**Subject:** O8W-PM 35217268, 35224712, 35224713 - Bucks Creek 1101 Phase 1,2&3 - Pre-Engineering

Meeting

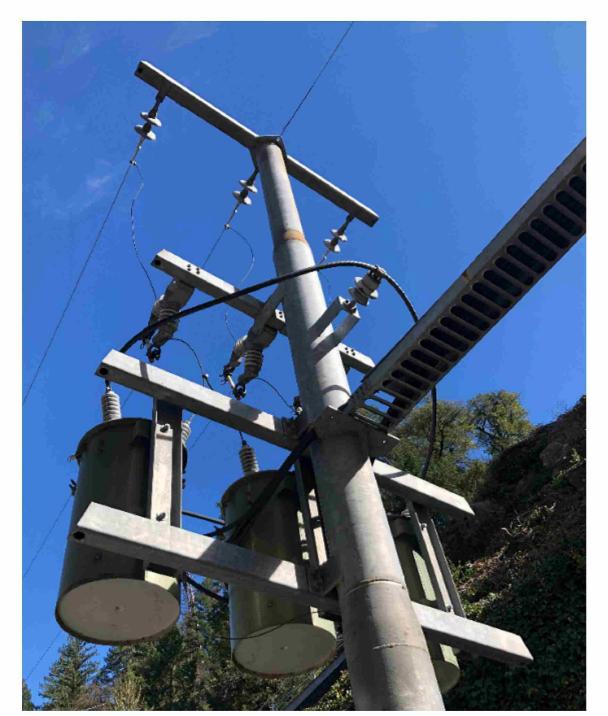
- 3. 'Underground' scope between locations 102 and 101 doesn't make sense when the following are considered:
  - a. How does this scope reduce risk?
  - b. Is 'undergrounding this small section 'constructible' when you consider the following:
    - i. Stairway, creek crossing, and proximity to sub-station
  - c. See picture

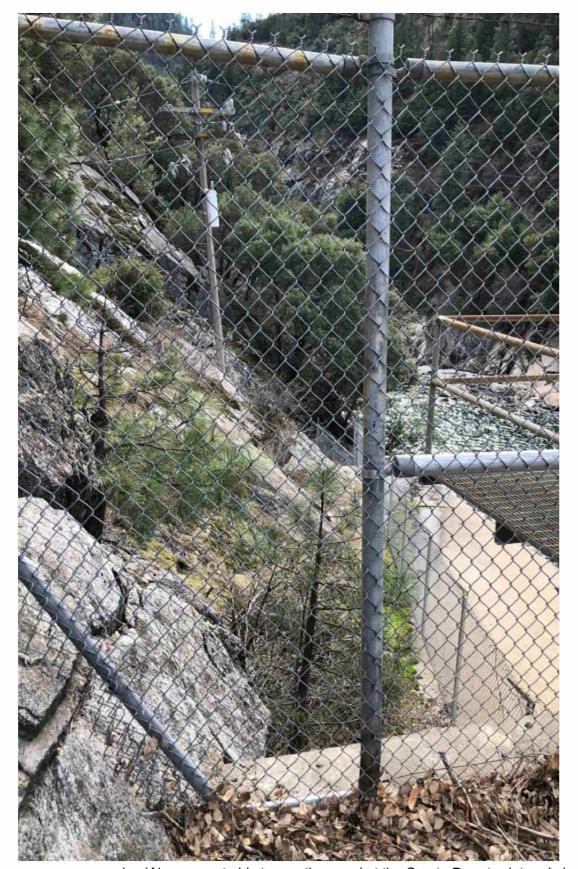
- 1. Preliminary Drawing was not provided
- 2. Trench Location:
  - a. We determined that landing the trench ~2' into the lane from the ETW (fog-line) was probably the best consistent location of which it would be ideal if the 7-boxes could be landed in the 'travel lane'. This will need to be discussed with Caltrans before moving forward with the design.
  - b. Any proposed poles to be placed within 52' from ETW if absolutely needed will need 'gaurdrail' protection to assist with DSDD exception requests.
- 3. Rock Creek Bridge Crossing
  - a. Scope is not clear for this crossing since it leads us to a 'what-if' scenario of, if Caltrans doesn't allow the conduits to be attached to the existing bridge we should span the river OH. This will need to be discussed with Caltrans to first determine 'if' we can attach to their bridge before scope is locked.
